CITY OF  
**SOUTHLAKE**  
*Department of Planning & Development Services*

**STAFF REPORT**

**CASE NO:** ZA15-068

**PROJECT:** Plat Showing for Lots 2-4, G.W. Main No. 1098 Addition

### Plat Showing

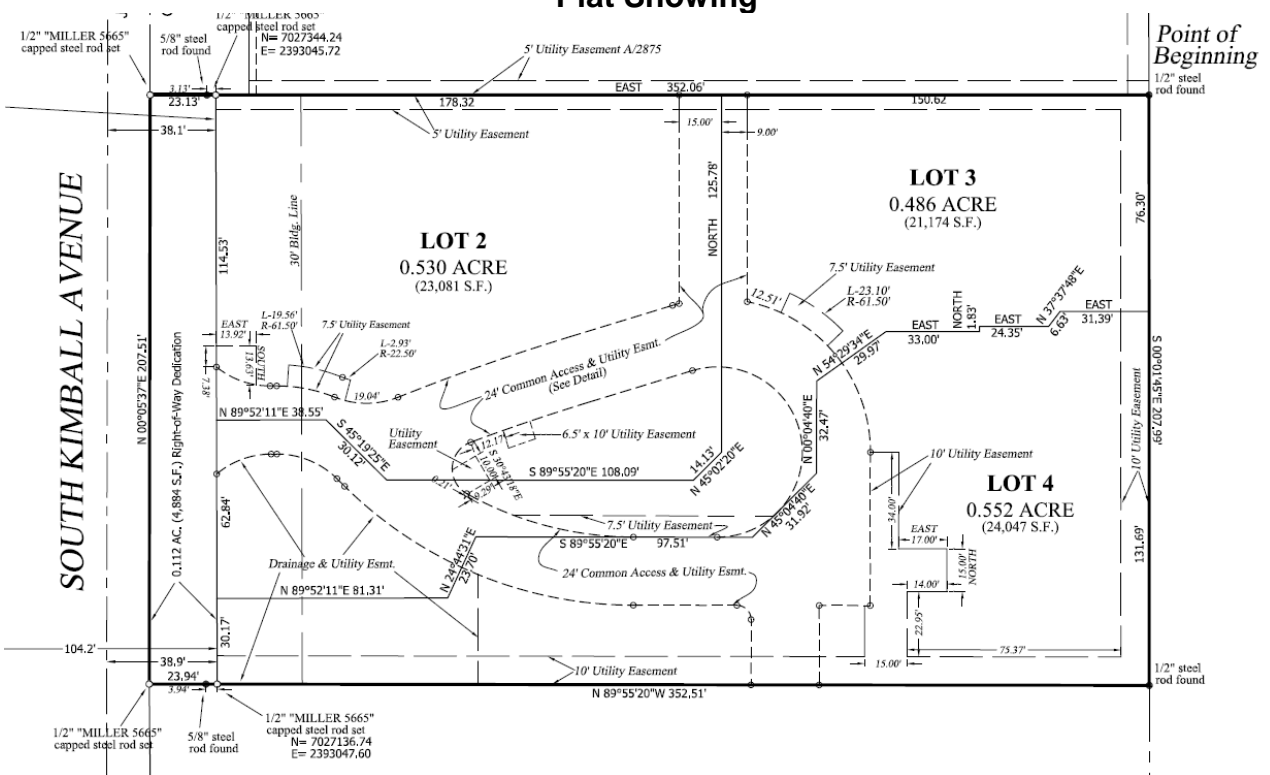
1. Approval of the Plat Showing is subject to conformance with the underlying zoning district and right of way dedication in conformance with the Master Thoroughfare Plan. Provide dedication in accordance with the current Master Thoroughfare Plan. S. Kimball Ave. is shown as a four-lane divided arterial with 88' of right of way. Dimension right of way dedication as 44' from centerline and also provide the full width dimension to the platted property on the west side of Kimball Ave.

3. The following changes are needed with regard to easements:
  - a. Provide easements for water, sewer and/or drainage in compliance with approved construction plans.

- b. Provide common access easements in accordance with the approved Concept Plan or Site Plan. The common access easement shown appears to match the location on the approved Site Plan.

- c. A 5' sidewalk is required along S. Kimball Ave. with construction of the development. If the sidewalk cannot be located completely in the right of way, please dedicate a pedestrian access easement in any location(s) where the sidewalk crosses onto the property.

1. This review is preliminary. Additional requirements may be necessary with the review of civil construction plans.
2. Show proposed sidewalks grades on the grading plans especially at the under sidewalk weir.
3. Label curb return radius for the proposed drive. Curb return radii for driveways shall be 30' minimum.
4. Fire lane radii shall be 30' minimum.

1. All water line stubs must have 2 joints past the valve with a 2" blow-off per the City's details. The 15' easement for the water at the dead end appears to encroach into the dumpster.
2. Commercial and industrial developments require fire hydrant spacing of 300' maximum for non-sprinkled buildings or 600' for sprinkled buildings.
- \* Water lines cannot cross property lines without being in an easement or right of way.
- \* The size of the water service tap must match the size of the meter. There are no reducers allowed before the meter on the public side. A one inch meter must have a one inch tap, etc.
- \* Water meters and fire hydrants shall be located in an easement or right of way.
- \* Fire lines shall be separate from service lines.

1. Runoff coefficients (C) for existing conditions shall be 0.35. Existing structure as shown do not appear to exist now.
2. Provide calculation to verify that the existing inlet can handle all the proposed flow from site as it appears that the existing inlet contributing area would not include entire EX-2 based on the contours shown in the Drainage area Map.
3. Proposed detention ponds shall control the discharge of the 1, 10 and 100- year storm events.
4. Provide the details of the will that surrounds detention ponds.
- \* Calculations will be required to verify capacity of proposed curb inlets.
- \* Storm sewers collecting runoff from public streets shall be RCP and constructed to City standards. The proposed flume will not be allowed.
- \* Provide inlet at the end of pavement of proposed street to intercept runoff before entering

Fire apparatus access, fire lanes, need to be an all-weather surface, asphalt or concrete, 24 feet wide and able to support the imposed loads of fire apparatus. (A minimum of 80,000 pounds GVW)

Fire lanes require a minimum 30 foot inside turn radius and a minimum 54 foot outside turn radius. (Per 2012 I.F.C. Sec. 503.2.4)

An additional fire hydrant is needed on the property due to the fire flow requirements necessary for the square footage of the buildings. (Locate along the east side of the property).

Pathway should be provided to each building and connect to the required 5' sidewalk on S. Kimball Ave.
